Duane Arnold Energy Center
Docket No. 50-331
Renewed Op. License No. DPR-49

Response to Request for Additional Information, License Amendment Request (TSCR-159) to Revise Technical Specifications Fuel Storage Requirements – MF7486

Response to Request for Additional Information, License Amendment Request
(TSCR-159) to Revise Technical Specifications Fuel Storage Requirements

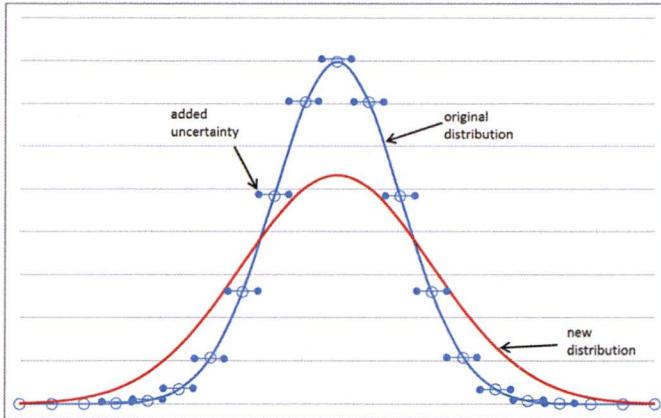
- a. Provide the basis for the conclusion that the BADGER tests results that fell below the minimum ^{10}B AD are solely due to uncertainties, given that the uncertainty identified in the LAR (0.0012 grams $^{10}\text{B}/\text{cm}^2$) is less than the difference (0.0027 grams $^{10}\text{B}/\text{cm}^2$) between the BADGER measured ^{10}B AD (0.0205 grams $^{10}\text{B}/\text{cm}^2$) and the certified minimum ^{10}B AD (0.0232 grams $^{10}\text{B}/\text{cm}^2$), as reported in the LER.

Statistics support the conclusion that the measurement uncertainty added by BADGER is the most likely cause. The results of the DAEC BADGER measurements documented in Revision 2 of the vendor report show the 60 panels measured had an average areal density of 0.0252 grams $^{10}\text{B}/\text{cm}^2$ and a standard deviation of 0.0016 grams $^{10}\text{B}/\text{cm}^2$. The population average areal density is close to the nominal areal density of 0.0250 grams $^{10}\text{B}/\text{cm}^2$, yet the population standard deviation leads to an uncertainty of 0.0033 grams $^{10}\text{B}/\text{cm}^2$, much larger than the initial as-built uncertainty of 0.0018 grams $^{10}\text{B}/\text{cm}^2$. When adding an uncertainty to a population, the resulting population will have the same average value, yet the new standard deviation will be the square root of the sum of the squares of the original and added standard deviations [$\sigma_{\text{new}} = (\sigma_{\text{orig}}^2 + \sigma_{\text{add}}^2)^{1/2}$]. The sketch below provides a pictorial representation of adding uncertainty to a distribution.

To account for the added measurement uncertainty, the new analysis documented in the LAR (Reference 1) does not use an uncertainty of 0.0012 grams $^{10}\text{B}/\text{cm}^2$. Instead, the new analysis uses a minimum areal density of 0.0150 grams $^{10}\text{B}/\text{cm}^2$, so the equivalent uncertainty, based on the nominal value of 0.0250 grams $^{10}\text{B}/\text{cm}^2$, is essentially increased from 0.0018 grams $^{10}\text{B}/\text{cm}^2$ to 0.0100 grams $^{10}\text{B}/\text{cm}^2$. The uncertainty of 0.0012 grams $^{10}\text{B}/\text{cm}^2$ is only applicable to the analysis for the Holtec racks.
